DEVELOPMENT HEARING OFFICER (DHO) APPLICATIONS

Plat for Volcano Mesa Being Comprised of Tract 2 The Trails, Unit 2 City of Albuquerque Bernalillo County, New Mexico June 2023

Re: Final Plat Review for Proposed Subdivision of Tract 2, The Trails, Unit 2 and Vacation of Portion of Easement [1]

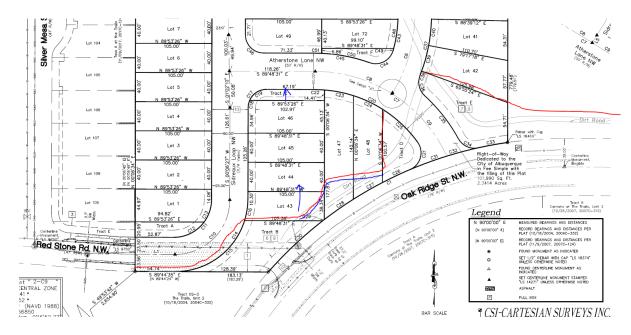
- A Preliminary Plat was previously approved on this site by the DRB on December 15, 2021 per PR-2021-005717 / SD-2021-00162 for 72 lots and 7 tracts. Additionally, four separate Waivers were approved by the DRB on that date with the Preliminary Plat. As a Final Plat was not submitted within 1-year of the DRB approval of the Preliminary Plat, the Preliminary Plat and four Waivers have all expired per Table 6-4-3 of the IDO.

- This Sketch Plat features the previously approved Preliminary Plat (also proposing a subdivision to 72 lots and 7 tracts) and four Waivers, while additionally featuring the proposed Vacation of a public drainage easement and a private access easement.

- All development must meet standards and provisions of the IDO (R-ML) and the DPM.
 Submitted plans should demonstrate how standards are being met for any applicable previous approvals and/or current standards.
 *Please clarify development type.

- All standards within IDO section 5-4-C (Subdivision of Land Compliance) apply to all replatting actions. Re-plating action cannot increase any existing nonconformity or create a new nonconformity. *Plans should demonstrate compliance of these standards.

"Drainage ponds for all residential subdivisions must use these Interim Guidelines to provide seeding on the pond bottom and aggregate with seeding for erosion control on the pond sides. In the 'notes' section of the Infrastructure list, include "Pond stabilization to follow Section 1013." In lieu of following these guidelines, the applicant may submit a landscaping plan for approval that will provide an equivalent or better outcome to erosion control, stabilization, maintenance, and aesthetic quality than these interim guidelines." Recent planning work has identified the value of continuing the east-west linear park and trail system that is well established through the Trails subdivisions to the west. With modifications to only three lots, this subdivision can continue this amenity that enhances the subdivision you are creating and provides east-west connectivity for the community in this area. (The red line below points out the open space that can be part of this system.) The connected open space maintains the natural desert ecosystem through this area. Could lots 43 through 46 be moved north to allow for an open space band along the north side of Oakridge? Could lots 47 and 48 be reduced from their unusually long dimension to provide the connection to Tract D? (The blue lines indicate recommended lot changes.)
